C2150x MAIN FIRMWARE RELEASE NOTES

WM-Ai & WM-Ai-P Auto Wrappers and IP-Ai Pre-Pack Scale

Version C2150W features & changes [22 January 2021]

Insertion Plate. Top: new coating (darker), bottom: original coating (lighter)

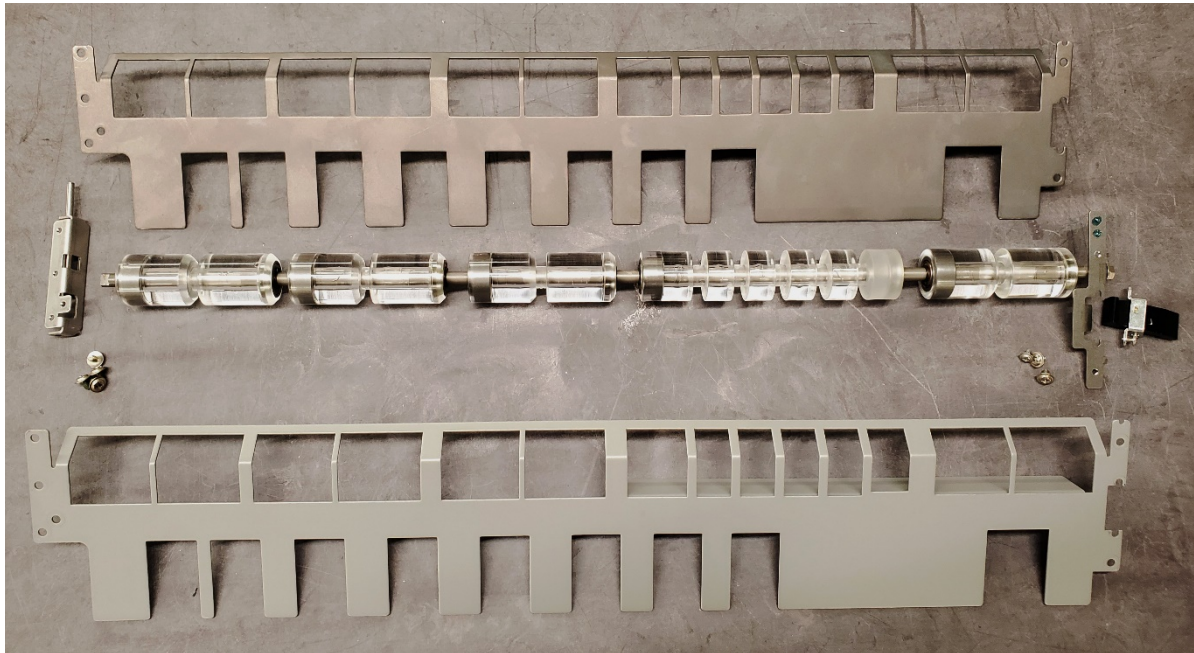
1. Added support for an updated Insertion Plate that is coated with a different material. An incorrect setting will affect film feeding. The updated insertion plate is factory installed on the WM-Ai-P model only from s/n 100504904, mfg. date October 2020. Adjust menu > Wrapping Machine > Film tab > Insertion Plate.
 - New – Set when the updated Insertion Plate is installed on an older wrapper
 - Old – Set when a wrapper has the original Insertion Plate (default)
 - SP – Set at the factory when new wrappers are built with the updated Insertion Plate
2. Fixed a bug where the last character of the date did not print when the Character Pitch spacing was set as zero (0).

Edit Print ID

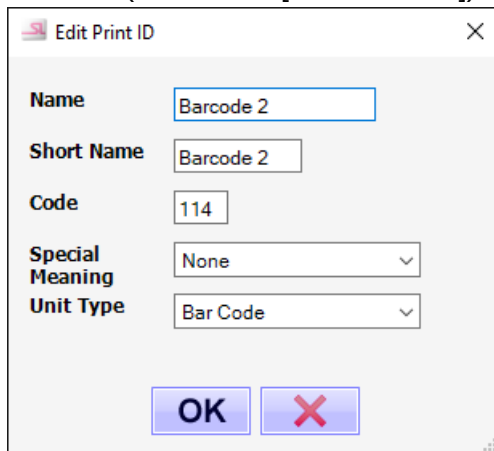
- g. Label format Print ID 134: BSP LOT (308 in SLP-5) is used to print the Lot Number. The field is changed from Numeric to Variable Text for this version of Lot Number.
